PRODUCT ADVISORY LETTER (PAL)

PRODUCT ADVISORY LETTER NO.: CU46-19004

(UPLC/UPLC-II Display Module not displaying clearly)

AFFECTED PRODUCT(S): UPLC-II

OLED Display Module

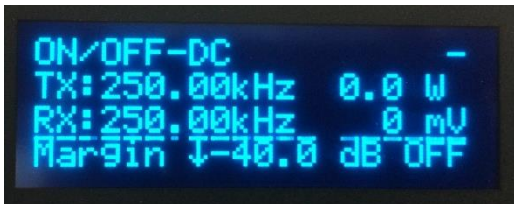
AFFECTED MODULE(S): Front Display Board CU20-DP1MN-001 Rev.11 (on white label) with OLED Display Module (shown below) that is displaying the symptoms below.

SYMPTOM(s): OLED Displays showing permanent horizontal or vertical lines or that are very dim. Pictures of some examples below:

CORRECTIVE ACTION: Call AMETEK Power Instruments Customer Services at **800-785-7274** to request an RMA for a Replacement Display Board with a later Rev OLED Display Module. This modification is available at no charge and will not affect any applicable warranty.
